STUDER

STUDER A827

"Software Update 50/92"

SI 158/93 Order No. 10.85.7340 d/e (Ed. 1093)

MP-UNIT AUDIO CONTROL MCH 1.827.788.24

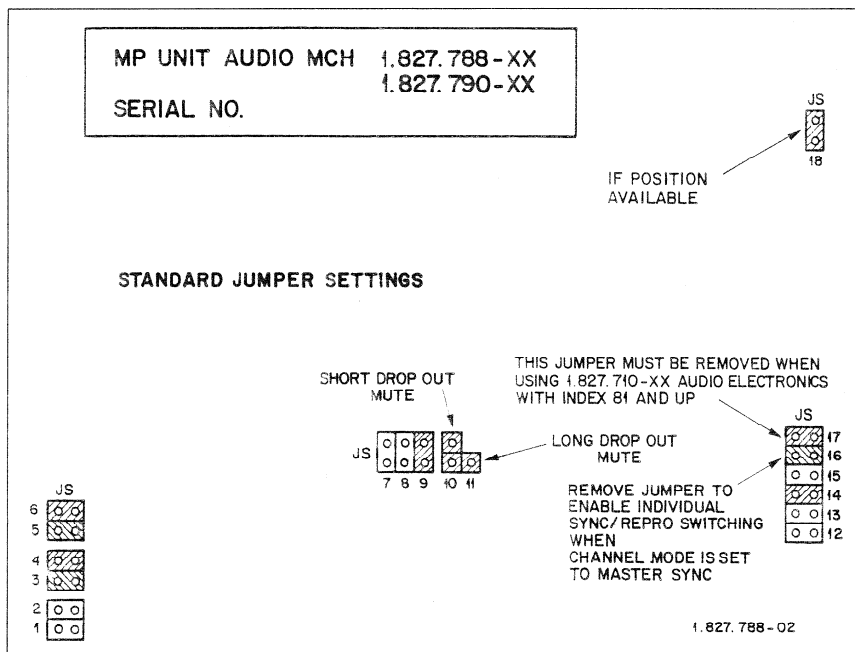
PC-Board 1.827.788.21 resp. .22
changes to **1.827.788.24 (50/92)**.
Software 1.827.989.21 (05/92) resp. .22 (10/92)
changes to **1.827.989.23 (50/92)**.

- Store data on tape.
- Change Software (3 IC's).
- **Erase RAM (IC 10)** (Put it on silver foil).
- Change PC-Board Index to **.24**.
- Modify MPU card by upgrade kit 20.050.754.12 or the corresponding spares according to the attached instruction.

MP-UNIT AUDIO CONTROL MCH 1.827.782.26

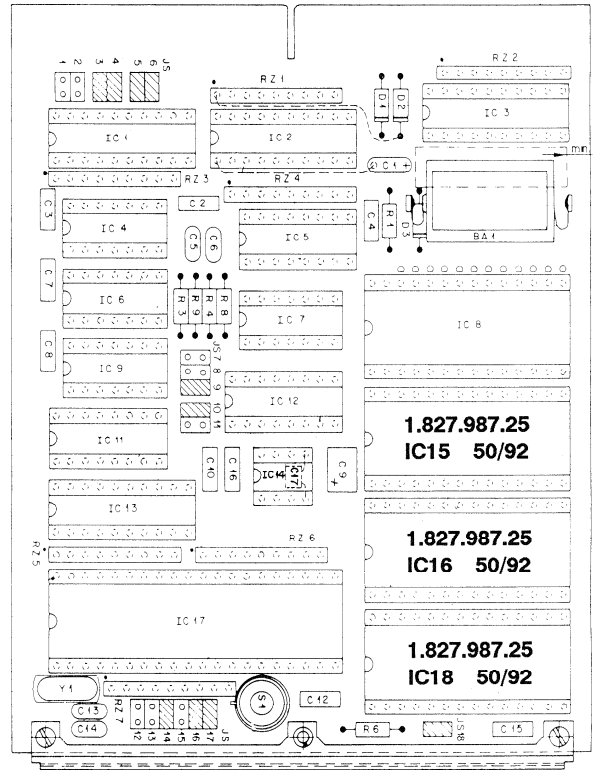
PC-Board 1.827.782.23 resp. .24
changes to **1.827.782.26**.
Software 1.827.987.23 (04/91) resp. .24 (10/92)
changes to **1.827.987.25 (50/92)**.

- Store data on tape.
- Change Software (3 IC's).
- **Erase RAM (IC 10)** (Put it on silver foil).
- Modify MPU card by upgrade kit 20.050.754.12 or the corresponding spares according to the attached instruction.
